ATTACHMENT 2

DETAILED ASSESSMENT

The site which is the subject of this Planning Proposal is 5-9 Gordon Avenue (known as SP 57091), containing 15 strata apartments.

Figure 1 – Site within the expanded Chatswood CBD Boundary

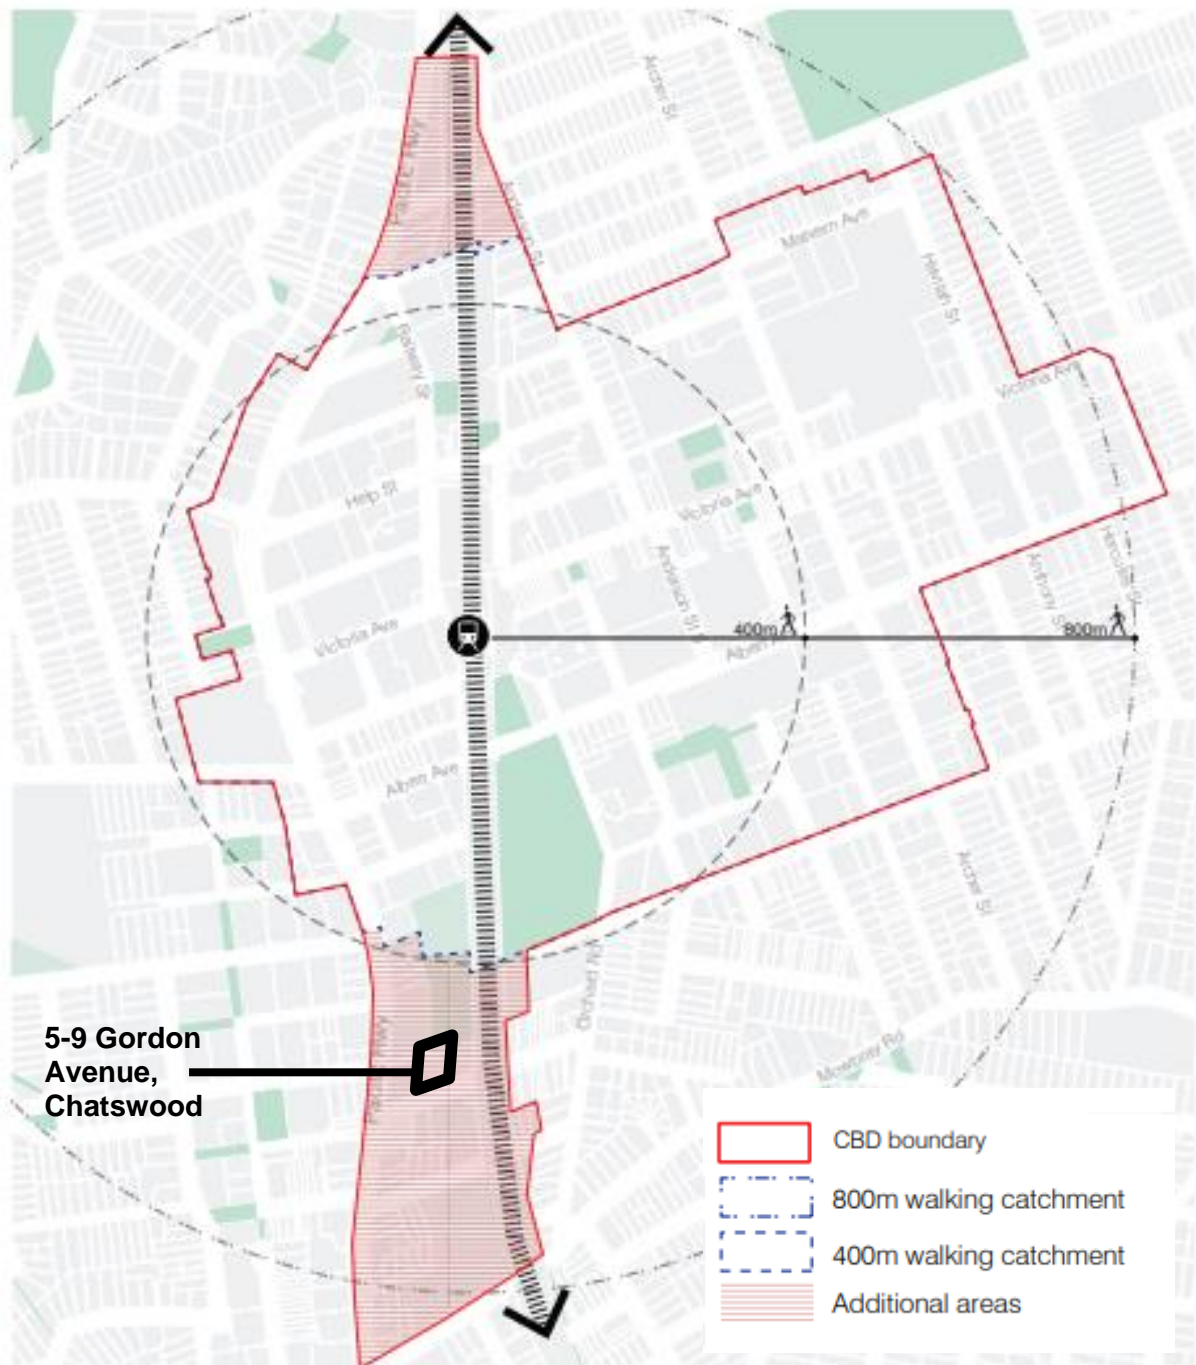
The Planning Proposal request is consistent with the CBD Strategy being within the expanded Chatswood CBD Boundary, as shown in Figure 1 below.

With regard to Key Element 1, it is considered that the Planning Proposal is consistent with the *Chatswood CBD Planning and Urban Design Strategy*.

Figure 3 – Base Floor Space Ratio

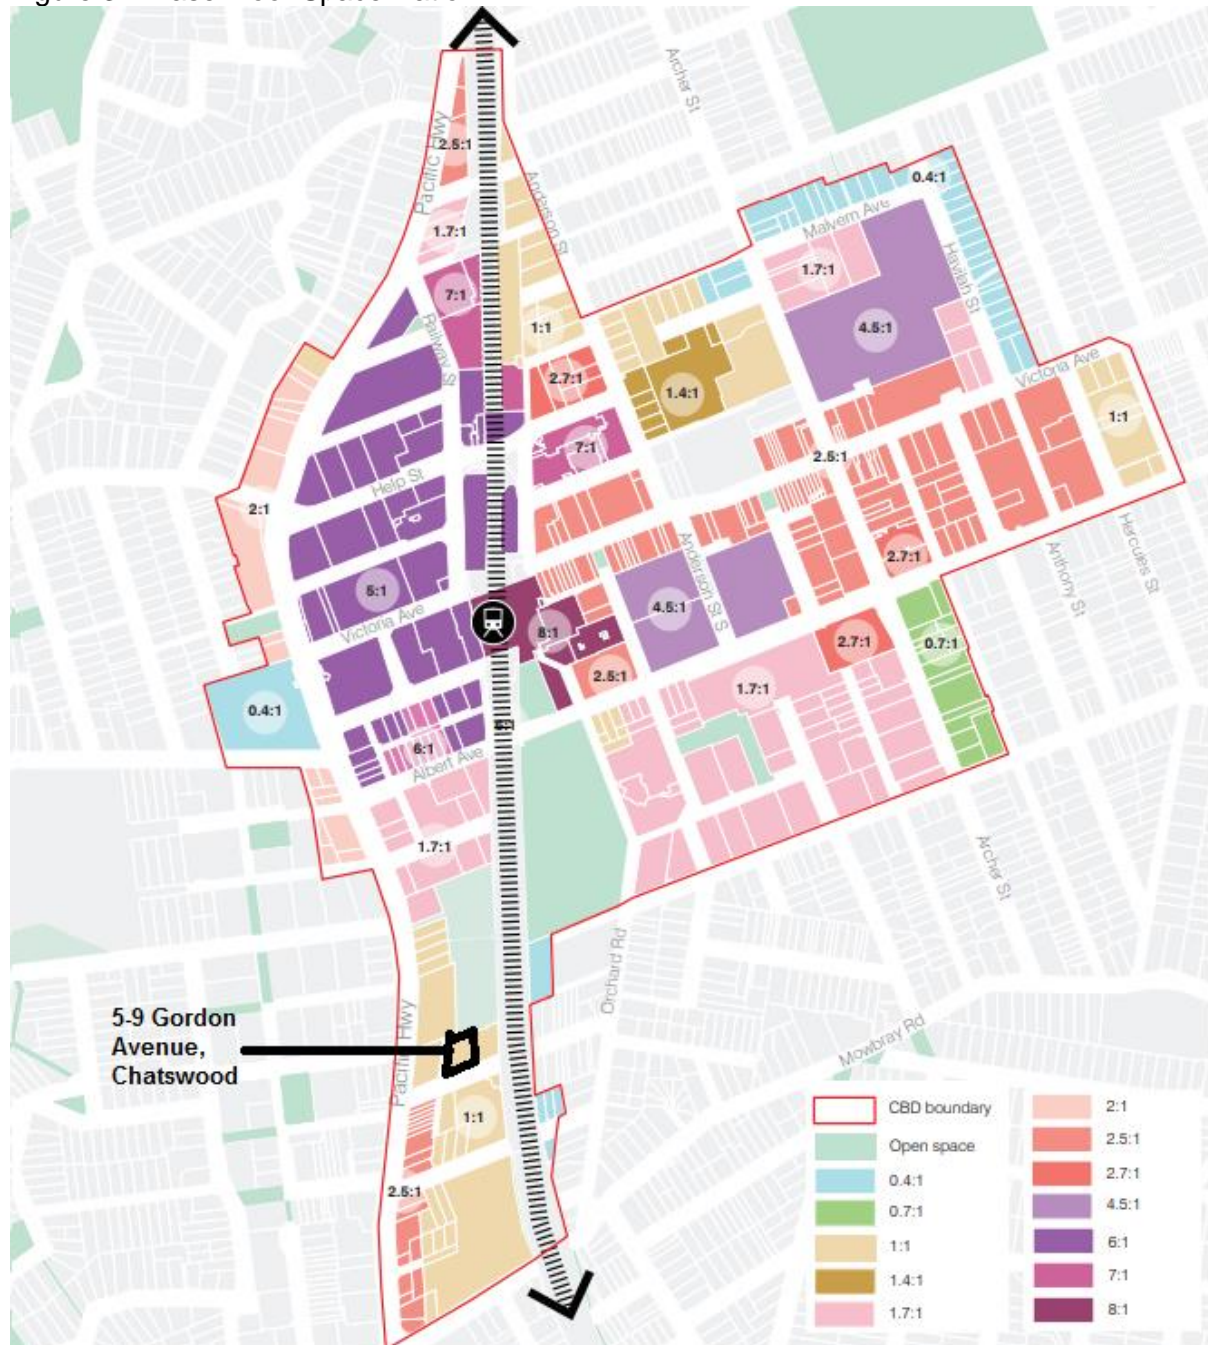
The site is in a location with a maximum base FSR of 1:1, as shown below in Figure 3- Base Floor Space Ratio.

The value uplift for the subject Planning Proposal is based on the maximum FSR of 6:1 minus the base FSR of 1:1. This issue is further discussed below in Key Element 12.

Figure 4 – Maximum Floor Space Ratio

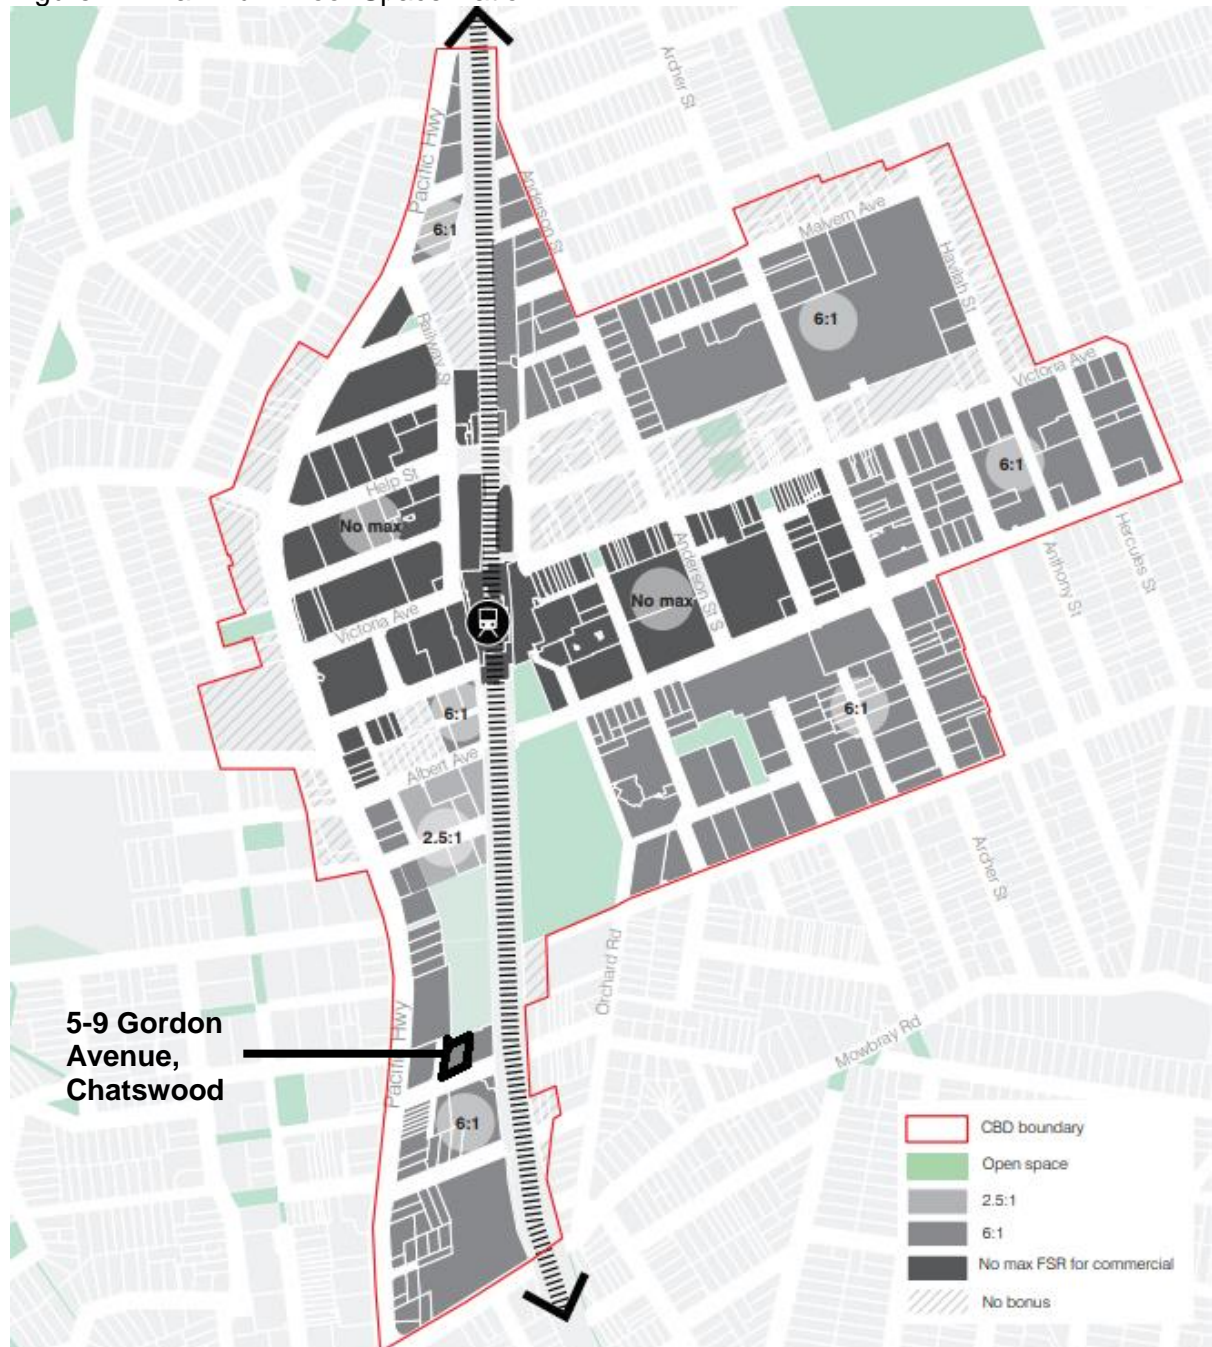
The subject site is in a location towards the southern edge of the Chatswood CBD (referred to in Key Element 13b) above as the outer centre with an FSR of 6:1, as shown below in Figure 4- Maximum Floor Space Ratio.

The Planning Proposal proposes a maximum FSR of 6:1, which includes affordable housing.

With regard to Key Element 13, it is considered that the Planning Proposal is consistent with the *Chatswood CBD Planning and Urban Design Strategy*.

Figure 5 – Sun Access Protection

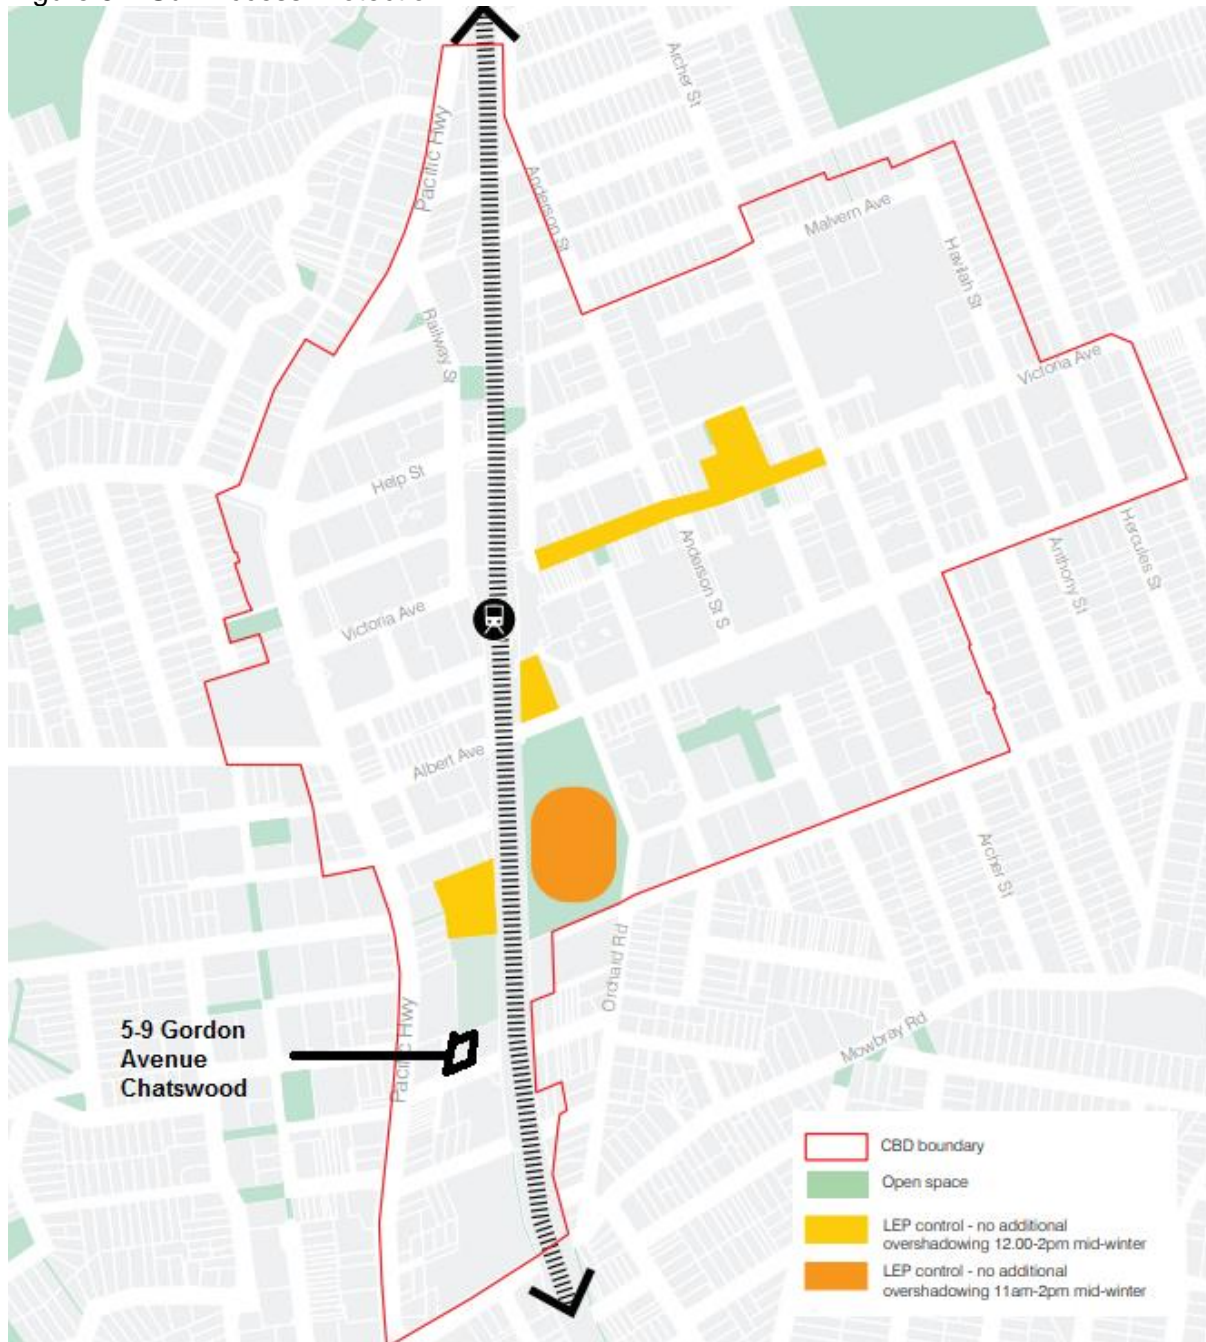
The site is located south of key public open space areas identified within the Chatswood CBD requiring sun access protection, as shown below in Figure 5- Sun Access Protection.

As a result of the site location, development on the subject site does not impact sun access protection to the public open spaces identified.

With regard to Key Element 19, it is considered that the Planning Proposal is consistent with the *Chatswood CBD Planning and Urban Design Strategy*.

Figure 6 - Height

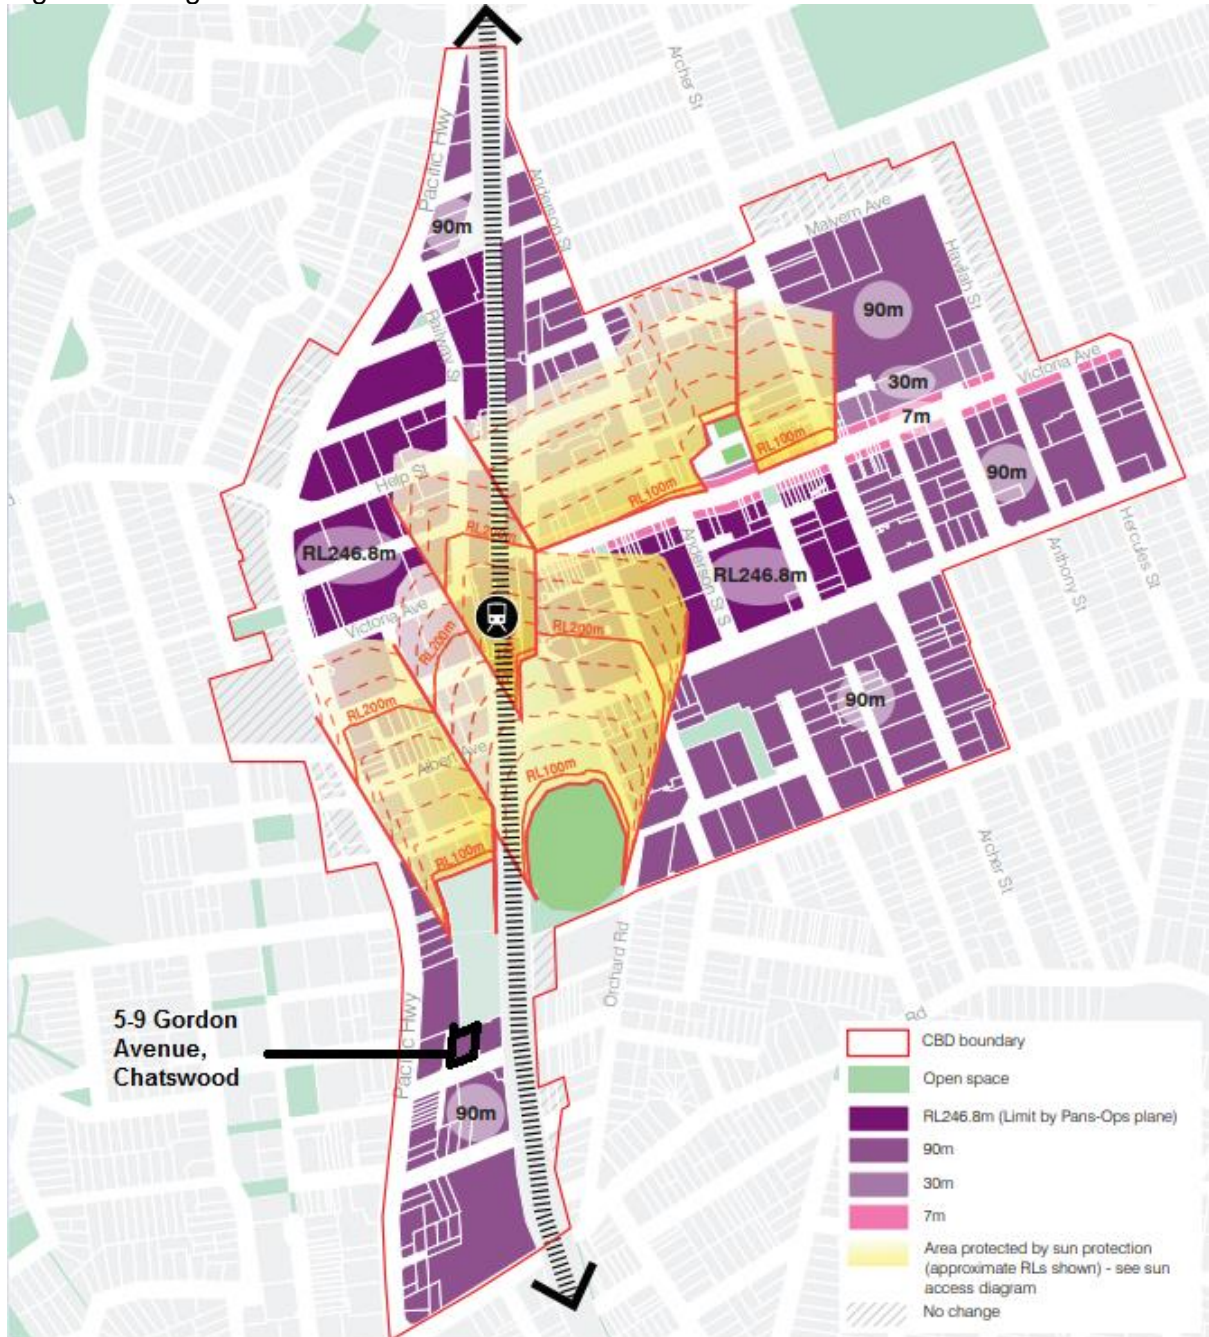
Figure 6 – Height below shows the height maximums in the Chatswood CBD, including where height is to be reduced in order to achieve sun access protection to the public open space areas identified in Figure 5 (above).

As a result of the site location, the maximum height of 90 metres is able to be achieved on the subject site.

The Planning Proposal provides for a maximum height of 90 metres and is therefore consistent with the Strategy. The maximum height requested includes provision for affordable housing as well as lift over runs and roof plant rooms.

Figure 7 – Links and New Open Space

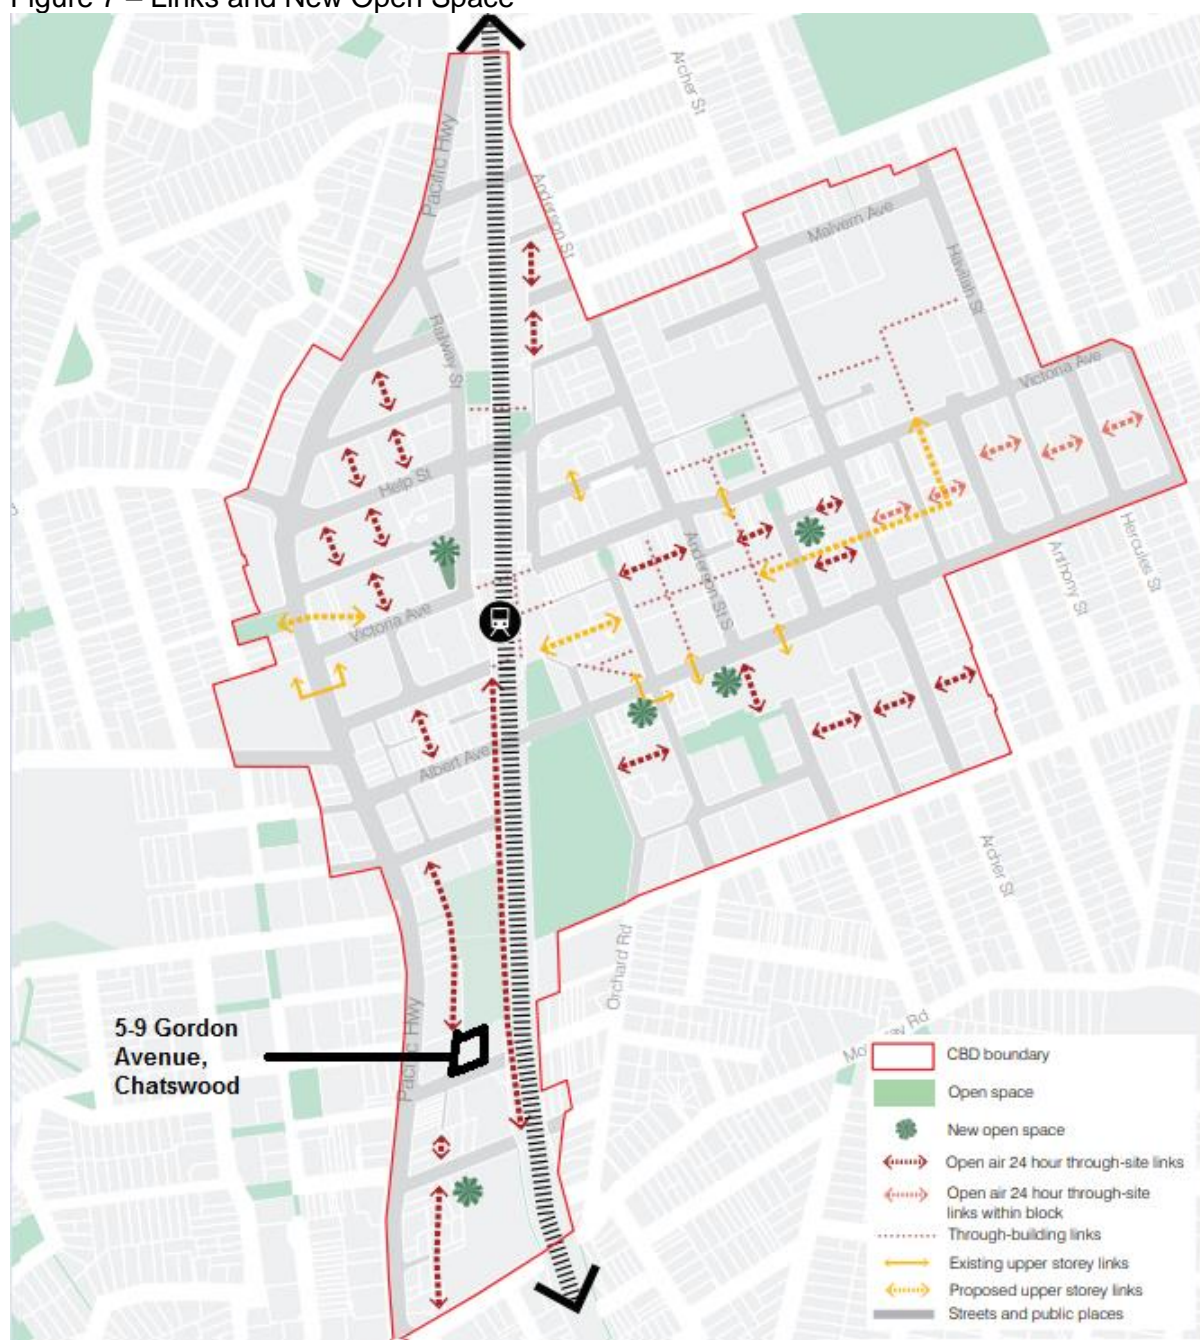
The site connects with identified existing or proposed pedestrian or cycle linkages at Hammond Lane. A new pedestrian footpath for Hammond Lane has been indicated in landscape concept planning in the Planning Proposal. There are extensive setbacks offered for both Gordon Avenue and Hammond Lane and Gordon Avenues footpath is indicated to be widened, with potential for an active transport linkage.

With regard to Key Element 22, it is considered that the Planning Proposal is consistent with the *Chatswood CBD Planning and Urban Design Strategy*.
